City of El Paso – City Plan Commission Staff Report

Case No: SUSU15-00011 Miles Subdivision Unit One Replat A
Application Type: Resubdivision Combination
CPC Hearing Date: April 23, 2015
Staff Planner: Alfredo Austin, (915) 212-1604, austinaj@elpasotexas.gov
Location: South of Americas and West of Socorro
Acreage: 2.274 acres
Rep District: 6
Existing Use: Vacant
Existing Zoning: C-4 (Commercial)
Proposed Zoning: C-4 (Commercial)
Nearest Park: Caribe Park (.43 miles)
Nearest School: South Loop Elementary School (1.04 miles)
Park Fees Required: N/A
Impact Fee Area: This subdivision is not within an impact fee area
Property Owner: Southwest Convenience Store
Applicant: Southwest Convenience Store
Representative: Conde, Inc.

ATTACHMENT 3

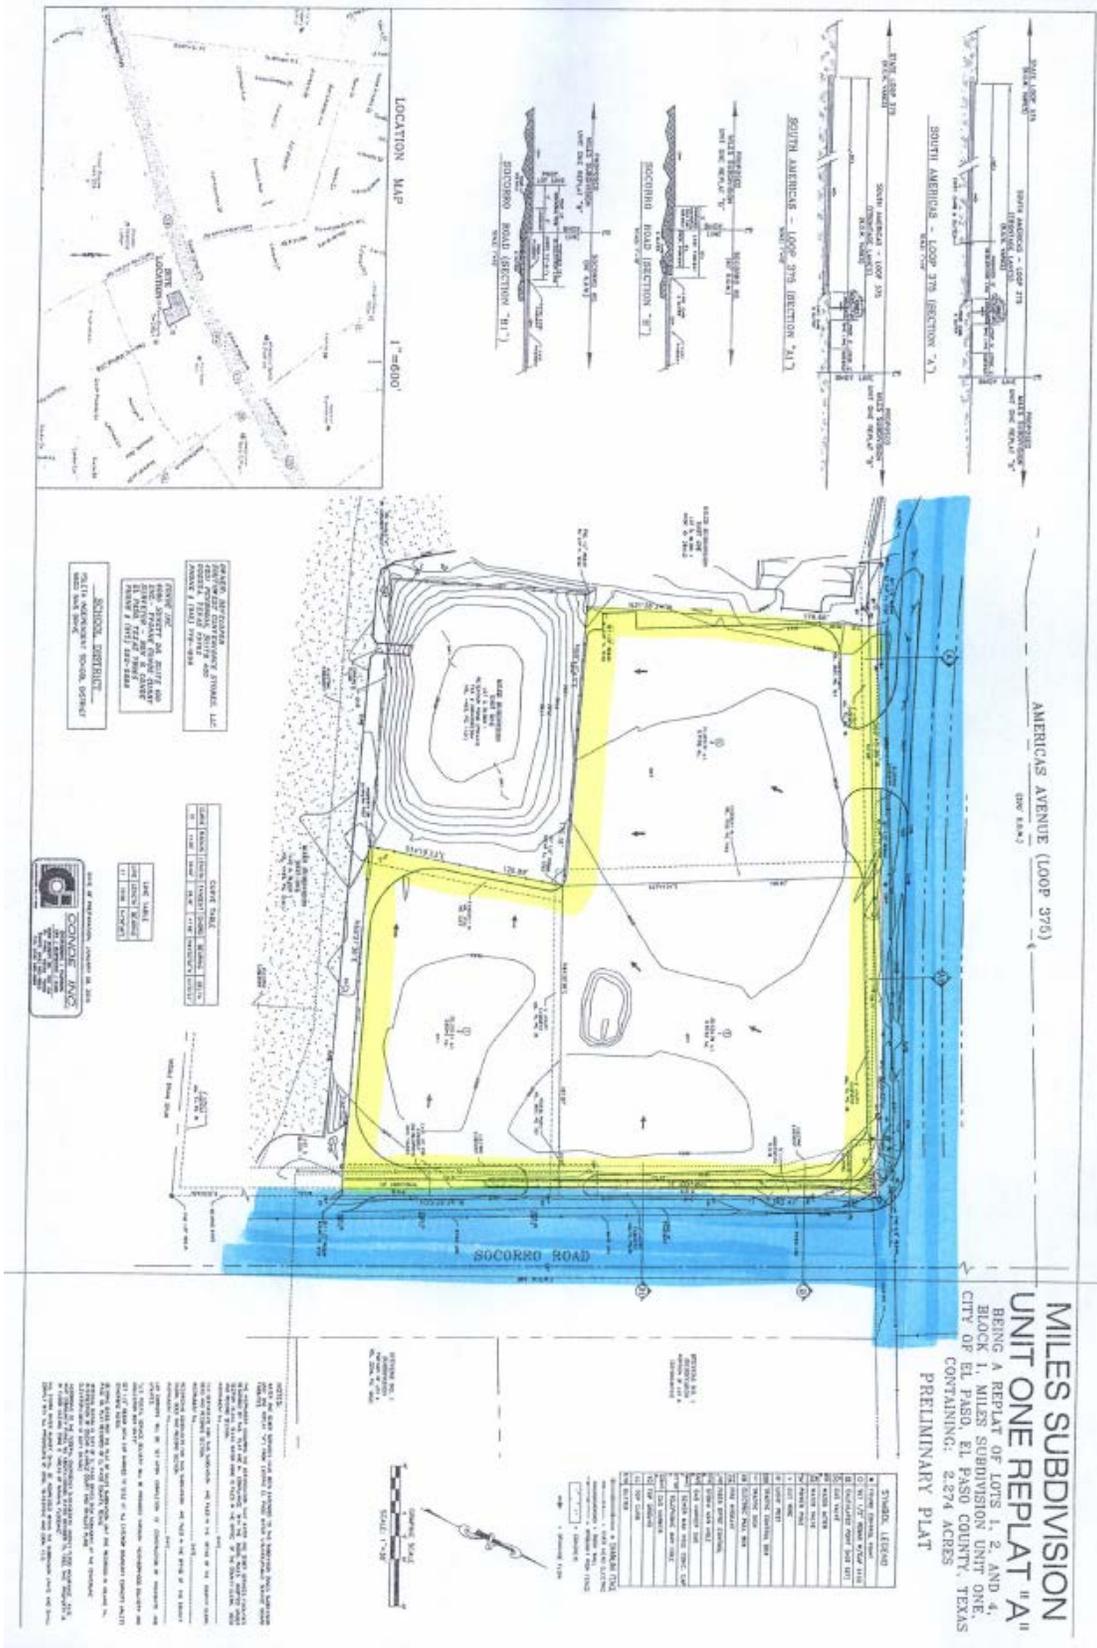
1. A storm-water drainage maintenance and access agreement for lots 1, 2, & 4 draining storm-water runoff into private pond (Lot 3, Block 1) is required.
2. Drainage easement is required for storm-water runoff from Lot 4 traversing Lots 1 and 2 into private pond. Label and dimension by bearing and distance.
3. Correction for last note “..within Miles Subdivision, Unit 1 limits..”.
4. Subdivision Improvement Plans are required due to ROW improvements.

The District recommends that the reference that Americas Ave is the same as Loop 375 be removed. Loop 375 and Americas Ave are not the same roads.
